Riley-Purgatory-Bluff Creek Watershed District
Board of Managers Regular Meeting
Wednesday, July 7, 2021 5:00pm Work Session Scheduled 7:00PM Regular Meeting
Virtual Meeting via ZOOM
<https://us02web.zoom.us/j/86875409929>

- f. Consider approval of request for variance from Rule D, Subsection 3.4 buffer monumentation requirements.
- g. Consider approval of permit 2021-017 Middle Riley Creek Stabilization Project as presented in the proposed board action section of the permit review report.

BARR PROJECT No.	23/27-0053.14
CLIENT PROJECT No.	
DWG. No.	D-02
REV. No.	0

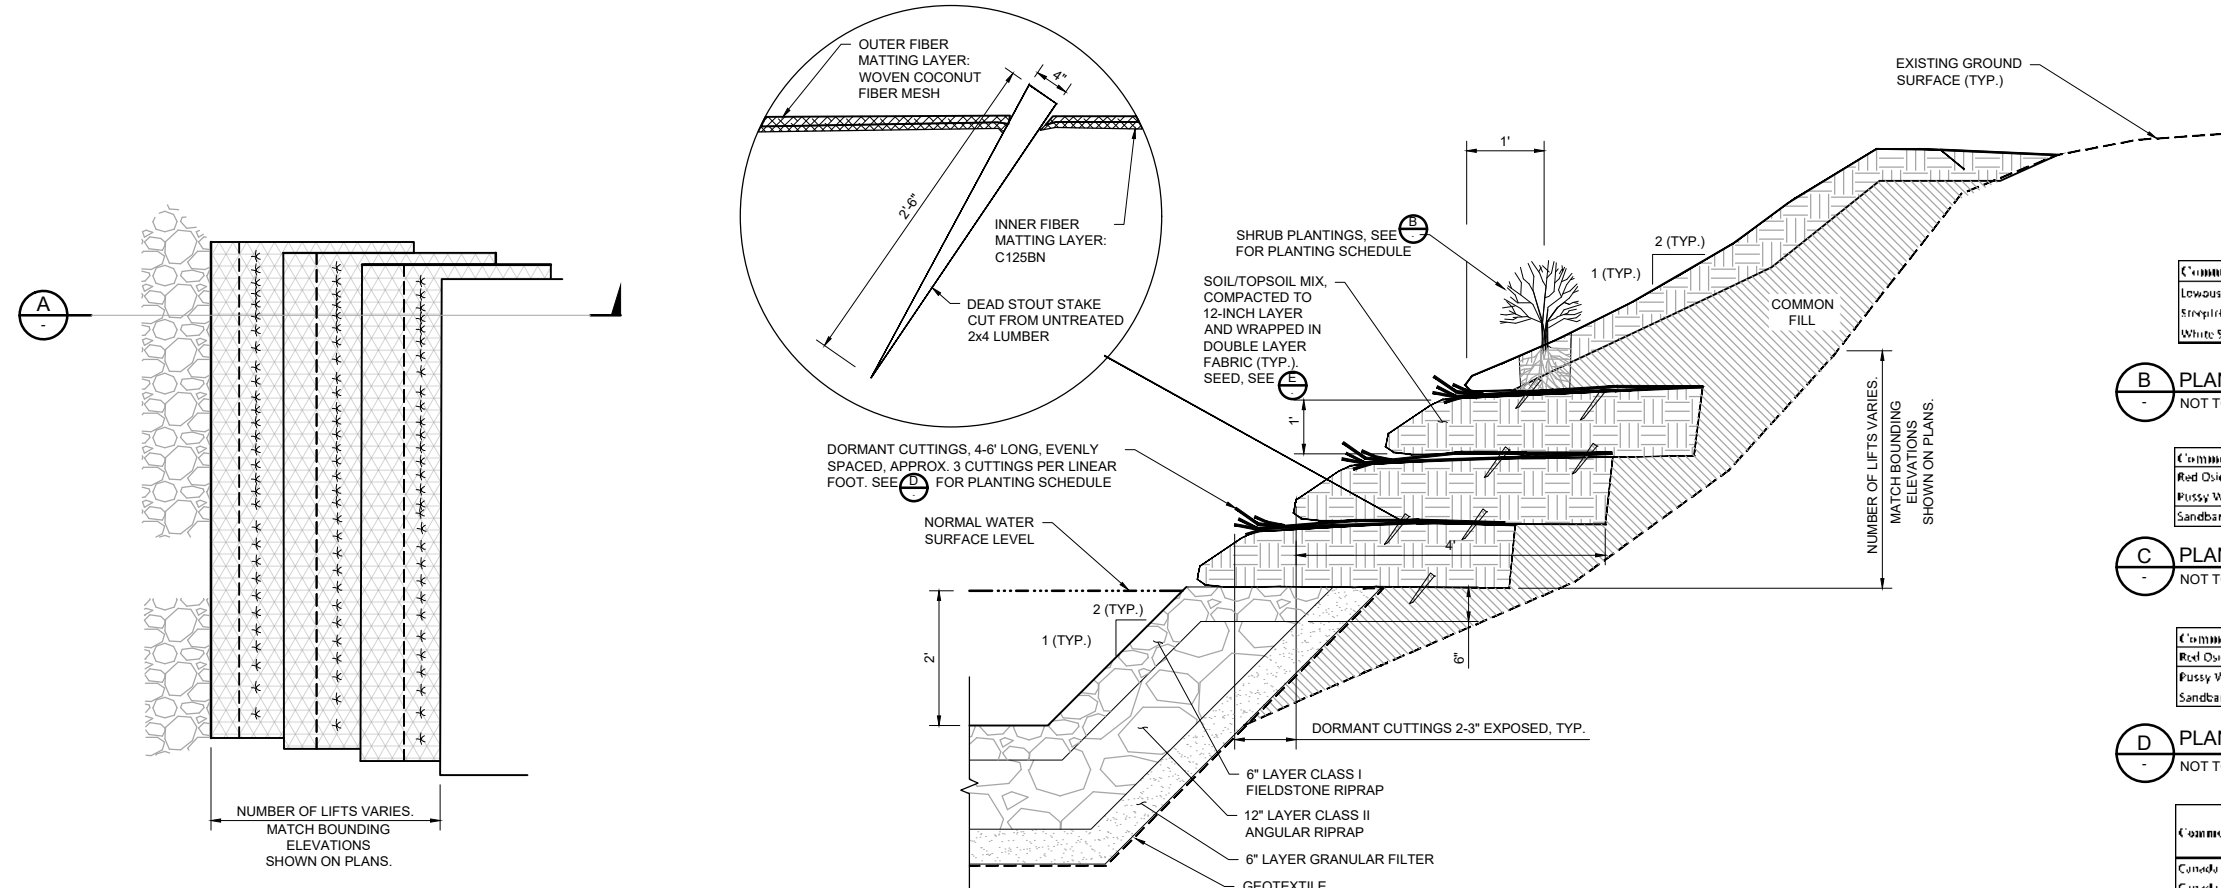
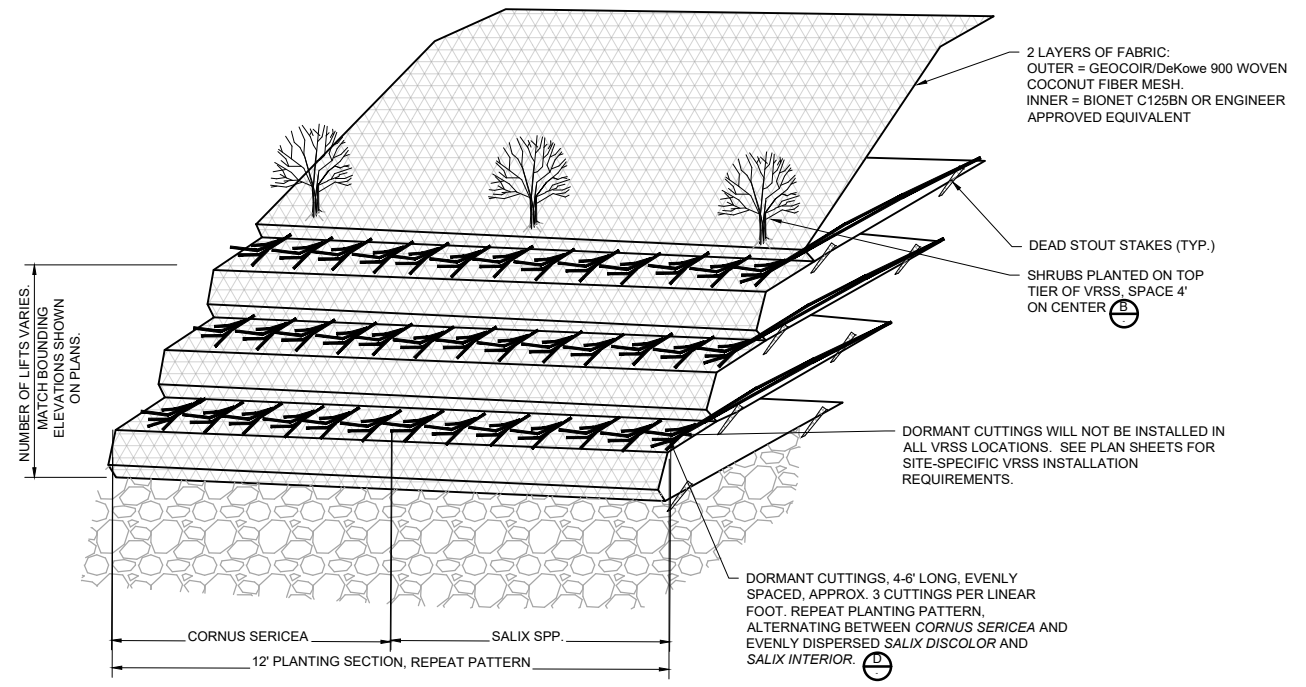
- F1. The vegetated riprap detail on sheet D-02 must be revised so the riprap will extend no higher than the top of bank, the finished stabilized slope will be 3:1 below the OHW, the riprap will not reduce the cross-sectional area (3.3.a.ii and 3.3.b.v).

BARR PROJECT No. 23/27-0053.14	
CLIENT PROJECT No.	
DWG. No. D-06	REV. No. 0

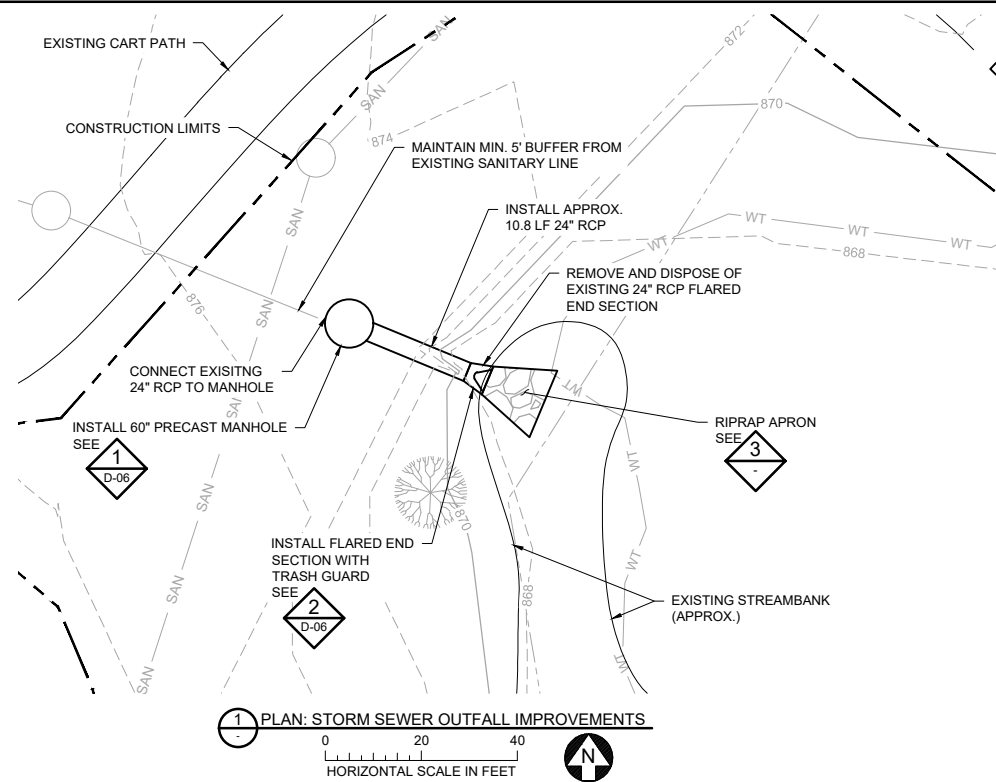
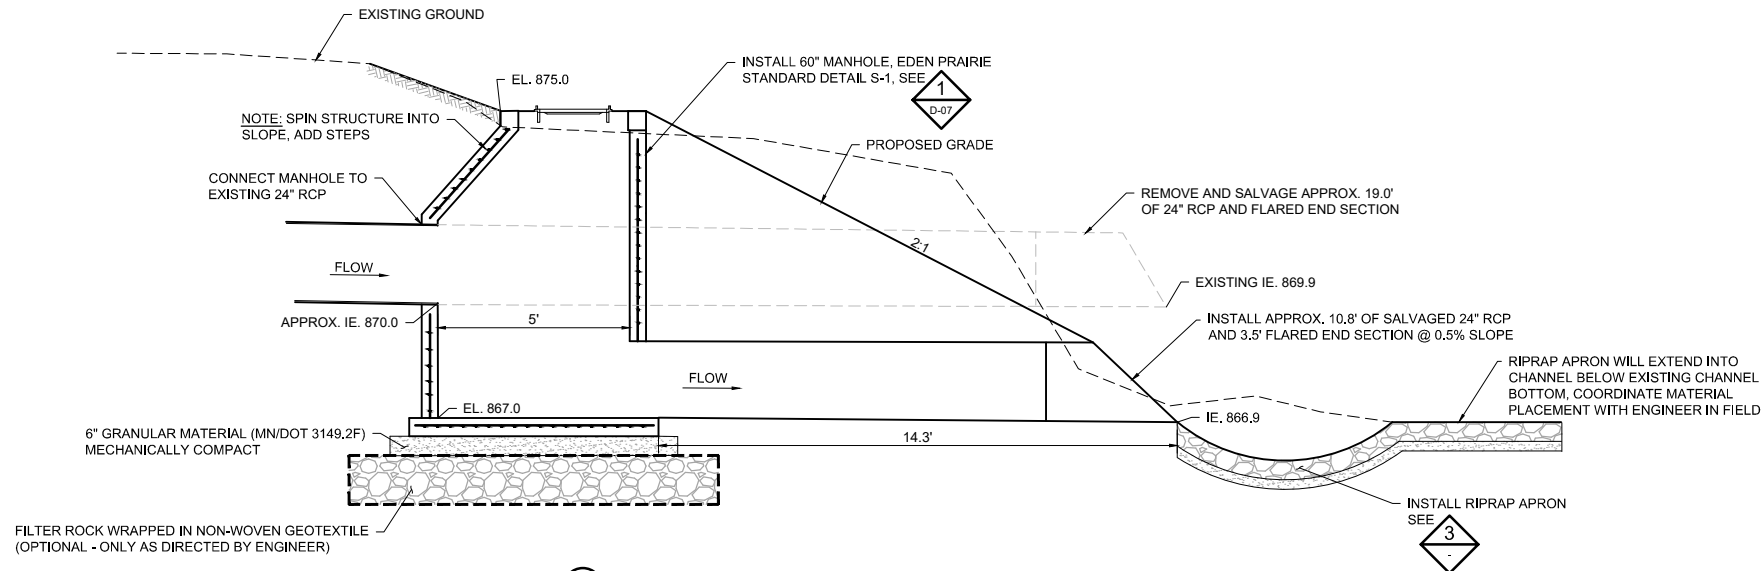
Criteria 3.3 is met because as shown on plan sheet D-06, the new flared end section will include a riprap apron and stilling basin to reduce risk of bank erosion. The flared end section will be replaced to prevent scour. Also, the drop into the new manhole structure will dissipate stormwater energy discharging into the channel. Because there is an upgradient, existing stormwater pond which will reduce peak flows and reduce pollutants the project conforms with criteria 3.3b and 3.3c.
